PLANNING COMMISSION  
MEETING AGENDA  
February 14, 2023  
7:00 P.M.

**Ditsch – Costco Site  
1100 East Kemper Road  
Application# 2023-0013  
February 14, 2023**

**DITSCH-COSTCO SITE**  
**1100 EAST KEMPER ROAD**  
**PLAN REVIEW APP #20230013**  
**23020103**  
**FEBRUARY 9, 2023**

**ENGINEERING PLANNING COMMISSION REVIEW**

2 DOCKS & BLDG ELEVATION - LOOKING NORTH - FUTURE  
1" = 30'-0"

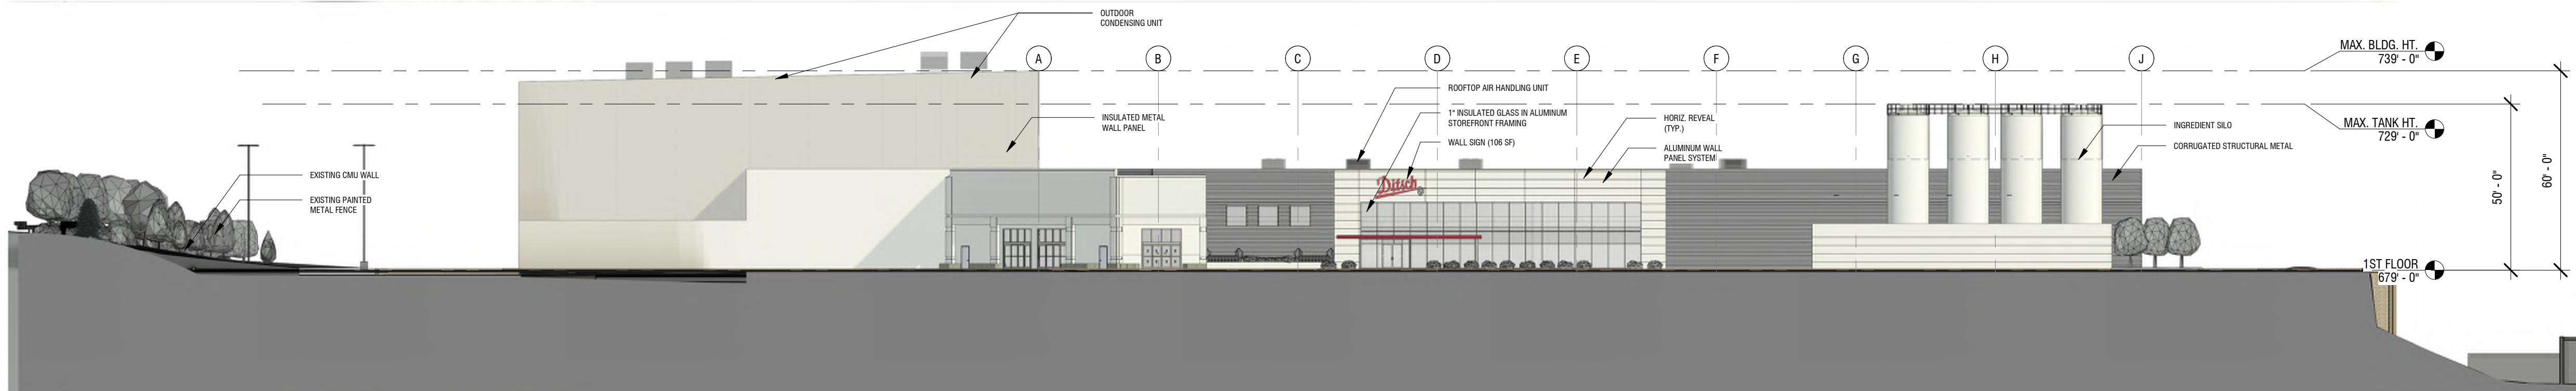
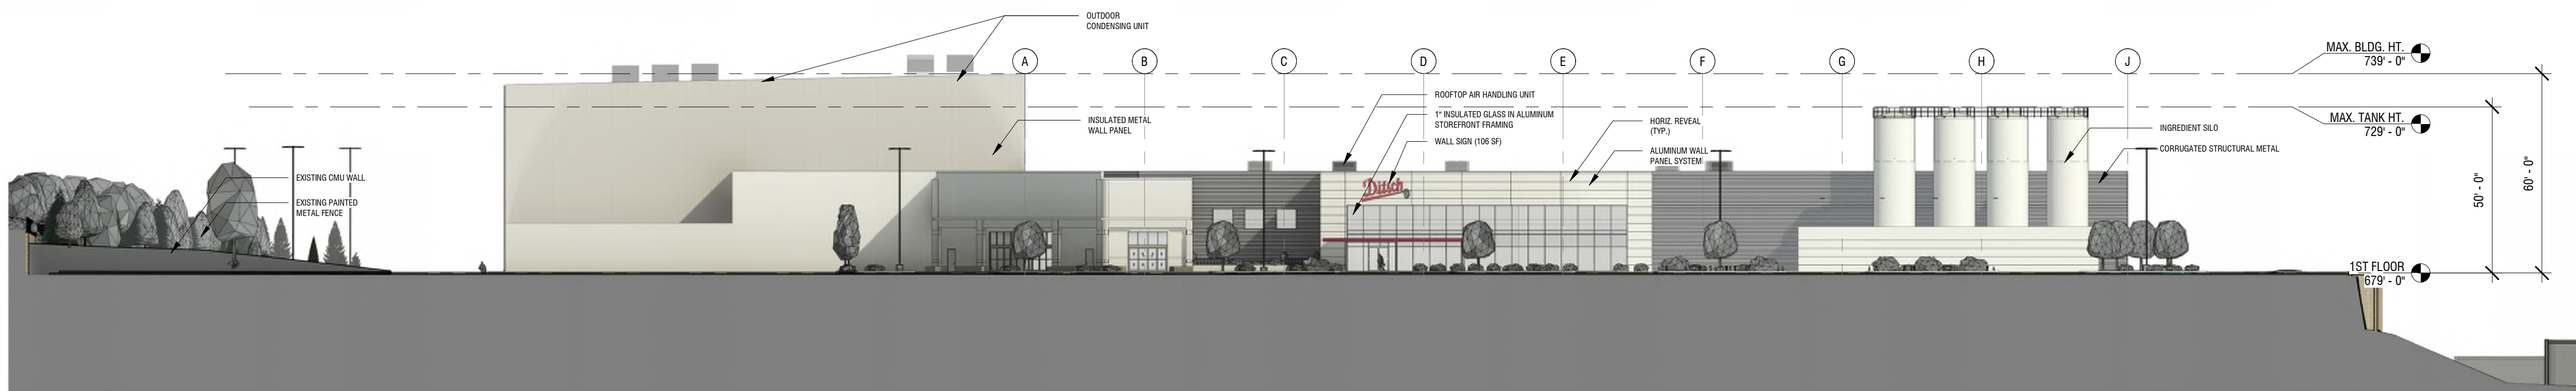
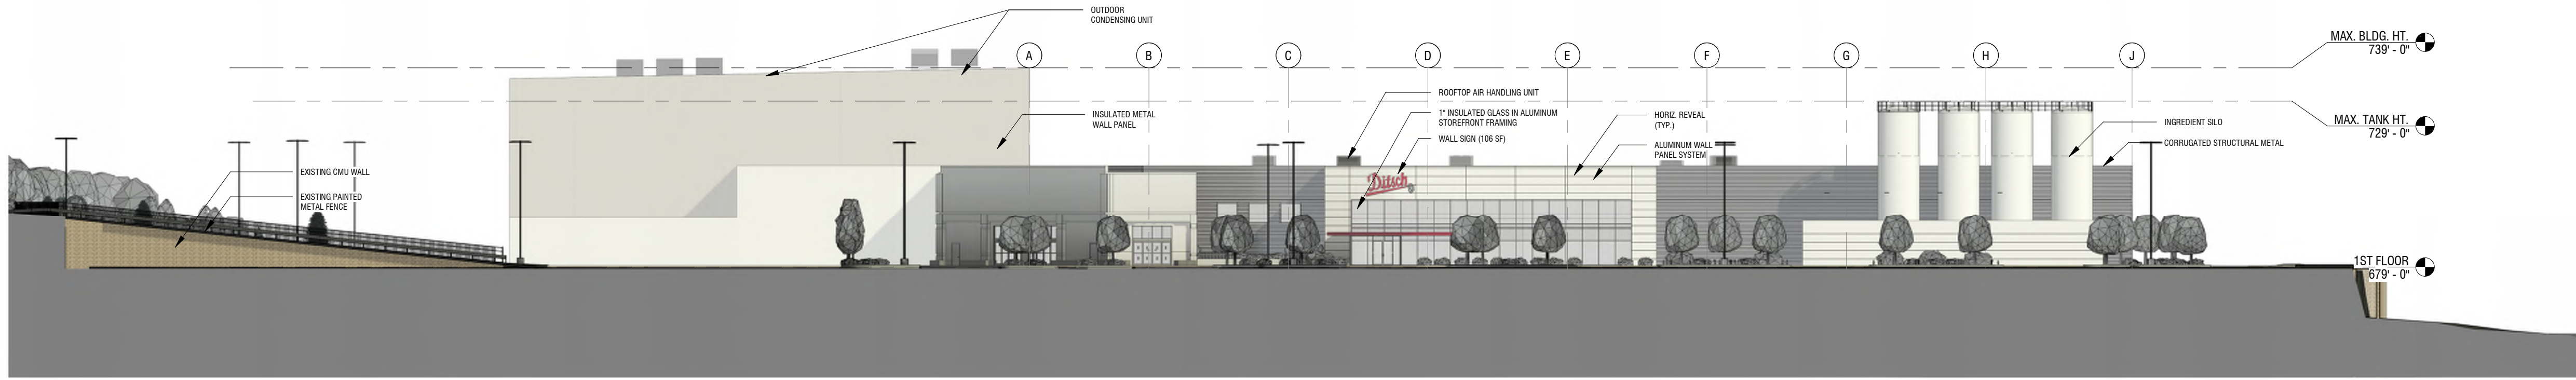
- 2) Four loading docks are proposed to be added to the southern end of the west building elevation. Per Section 153.303 (B) (1), loading spaces are not permitted in a front yard. Planning Commission and Council would need to approve the proposed location pursuant to Section 153.255 (F) (3) (c). Screening, per Section 153.303 (C), will be provided with the Final Development Plan.

- 7) Eight silos (50 feet in height) are proposed for the southeast corner of the building. The eight silos will be considered accessory structures per the definition contained in Section 153.600. As such, unless modified by Planning Commission and Council, they would need to comply with the provisions of Section 153.253 (E) (20) unless it is determined that unusual conditions exist per Section 153.253 (F) (3) (c). Section 153.253 (E) (20) requires the following relevant provisions for accessory structures:

Any mechanical equipment located at the top of the silos will need to be screened. All new roof, silo, or ground mounted equipment must be screened per the requirements of Section 153.254 (C). Screening details will need to be provided with the Final Development Plan.

- 2) Planning Commission determine that per Section 153.255 (F) (3) (c), unusual conditions exist which should allow for the construction of four loading spaces on the south end of the west building elevation in a front yard which is not permitted in a front yard pursuant to Section 153.303 (B) (1). The Final Development Plan will contain site and landscape plans to document compliance with Section 153.303 (C) unless modified by Planning Commission.

front building elevation, and that the requirements of Section 153.303 (B) (1) are to be demonstrated to the greatest extent possible on the Final Development Plan. Any mechanical equipment on top of the silos is to be screened.

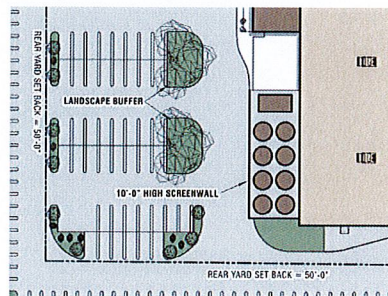
- ii. A truck swept path analysis (AutoTurn) of the existing entrance to remain on Commons Drive was provided to verify that semitrailer trucks can enter/exit the site without tracking on to opposing traffic and/or outside the pavement areas. The submitted diagram shown below is acceptable to Staff.
